PROPOSED OFFICE REMODEL
119 WASHINGTON AVE SU. 502
MIAMI BEACH, FL

April 12, 2019

Re: BC1910562

Below please find our responses to Disapproval Remarks regarding the above referenced project.

sheet
A-2

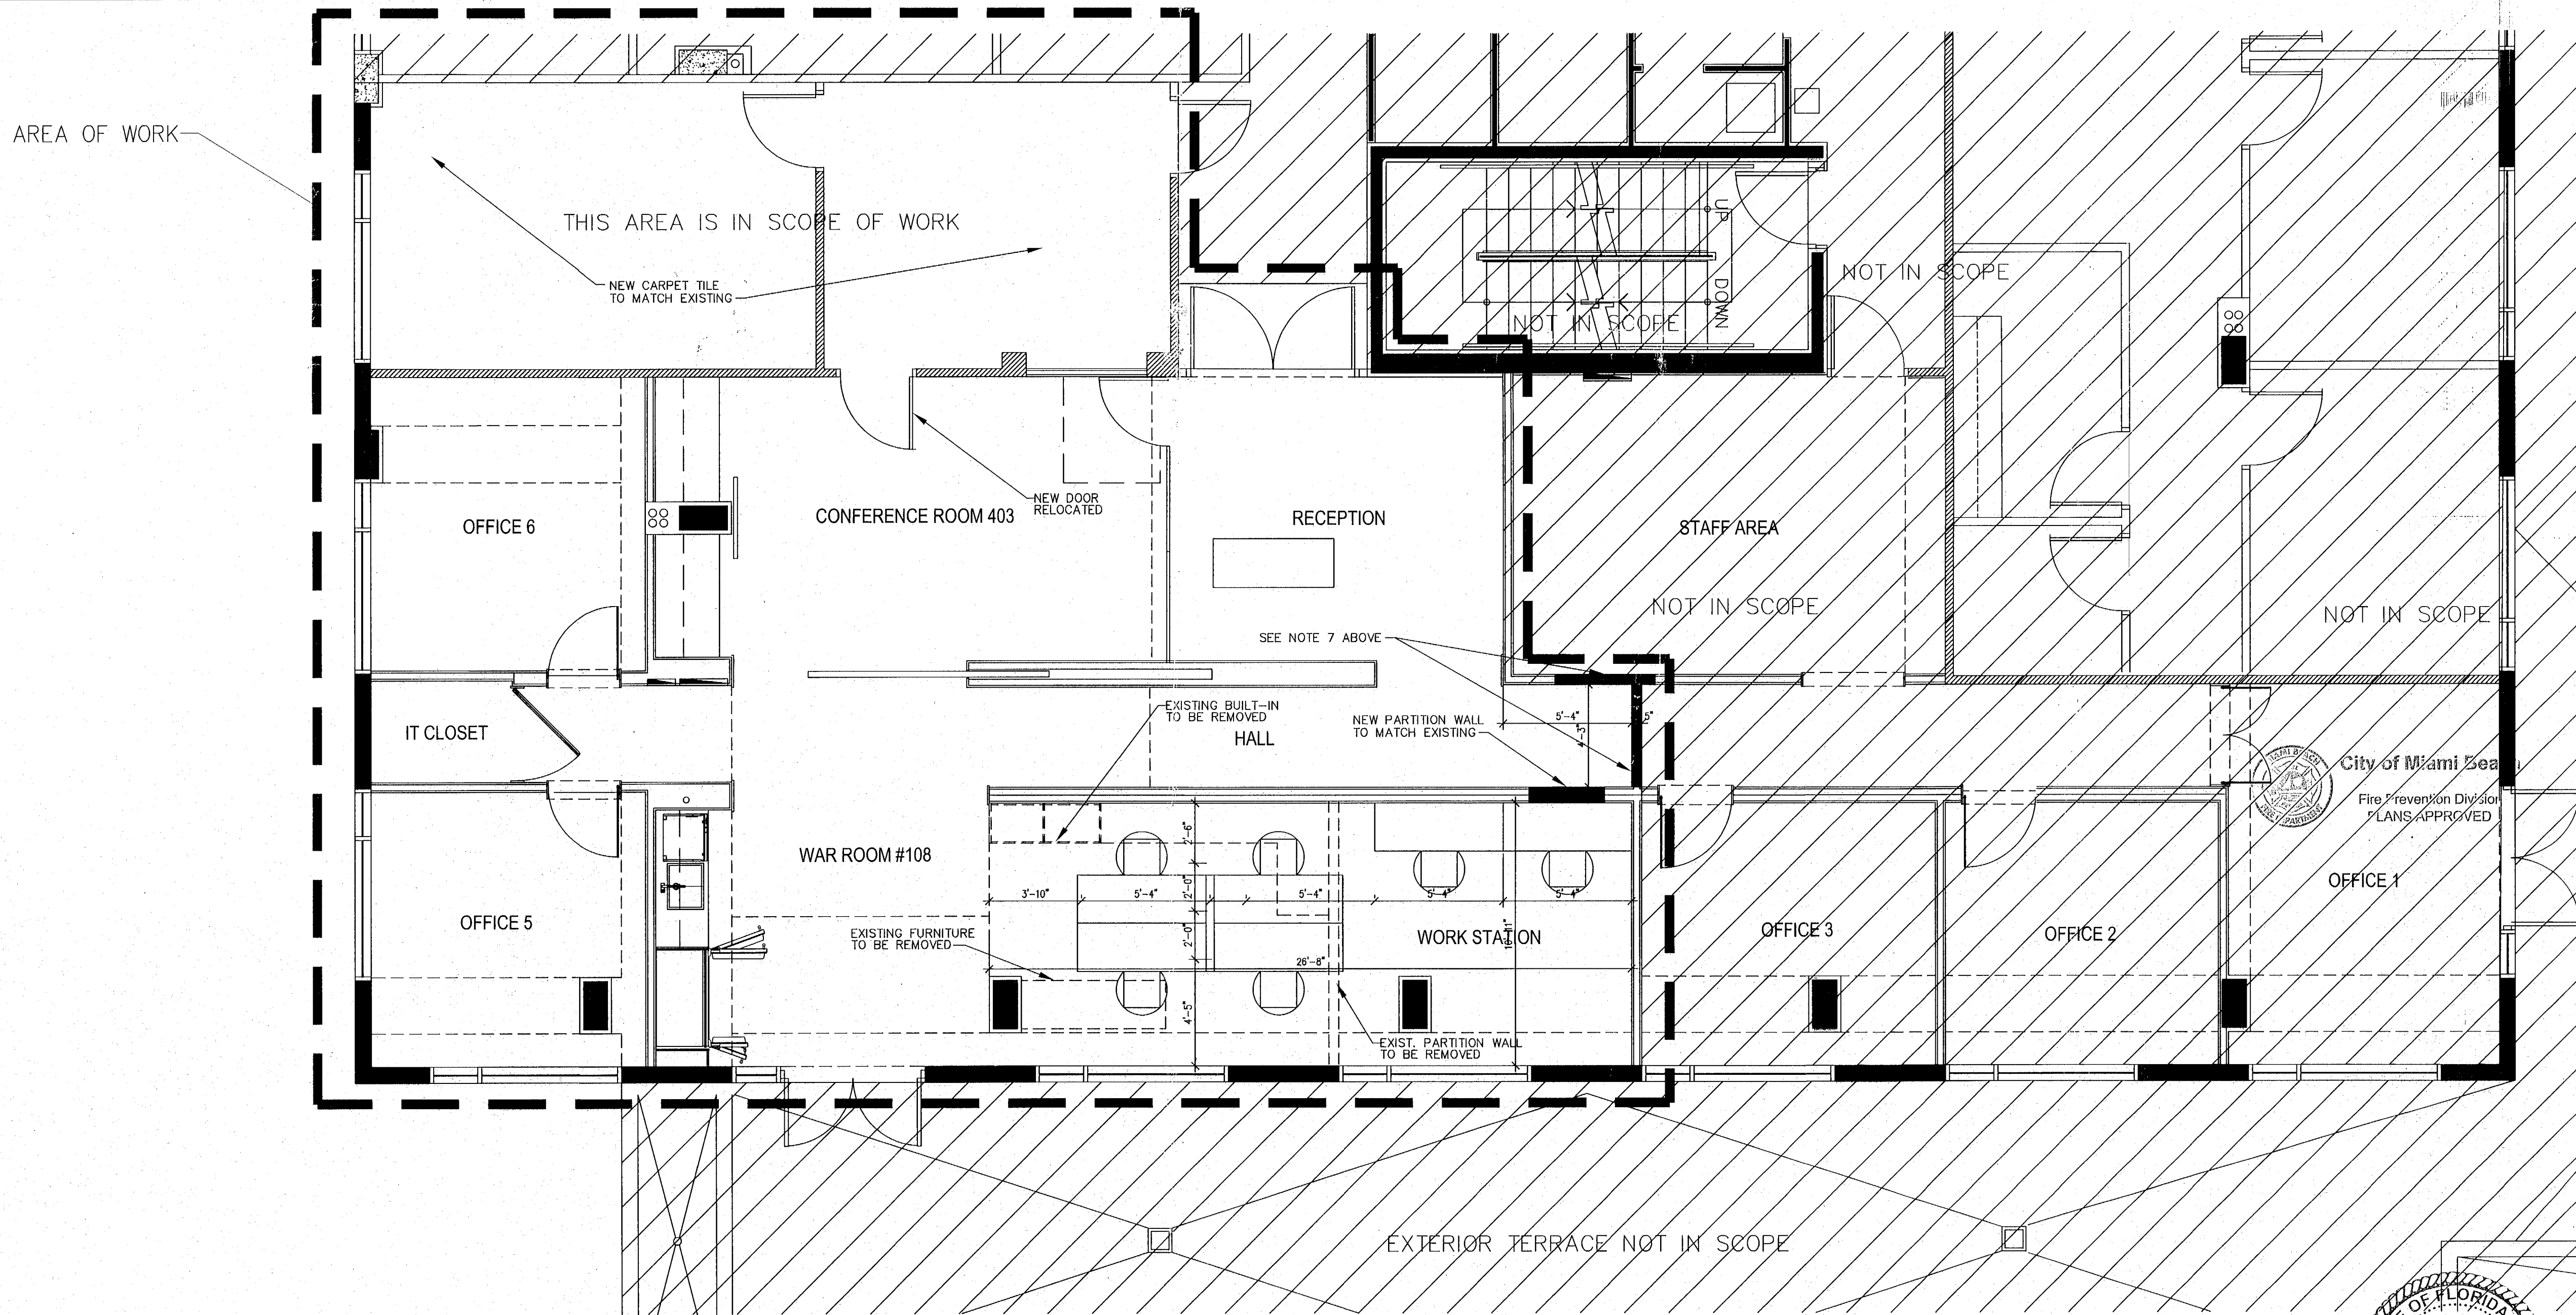
3. Total gross construction (Not just AC) area, including covered terraces and garages (open or enclosed within walls or columns) should be reflected on the application and on plans as areas of new construction/alteration (or Work Area). FBCB 107.2.1

4. Codes to be applicable shall be clearly written on the first page of plans. State that code in effect is FLORIDA BUILDING CODE 2017, 6th Edition and FLORIDA BUILDING CODE ACCESSIBILITY 2017, 6th Edition. All other applicable codes for the other trades must be listed. If the proposed work is on an existing building work shall be classified as per FBCBE (Existing) 2017 Chapter 5.

6. Calculate occupant load and compare it with egress capacity. FBCB 107.3.5, & table 1004.1.2.

7. Show details with an NRTL approved system (UL or equal) number for all fire rated walls, partitions, fire barriers, Chases, etc. FBCB Chapter 7

8. Provide sound insulation: Walls, partitions and floor-ceiling assemblies separating dwelling units from each other and from public or service areas shall have a sound transmission class (STC) of not less than 50 (66 for wood joists floor). Floor assemblies shall also have an impact insulation class (IIC) of not less than 50 (66 for wood joists floor). FBCB 1207

See revised sheet A-2

See revised sheet A-2

See revised sheet A-2

See revised sheet A-2

See new detail U419 sheet A-2
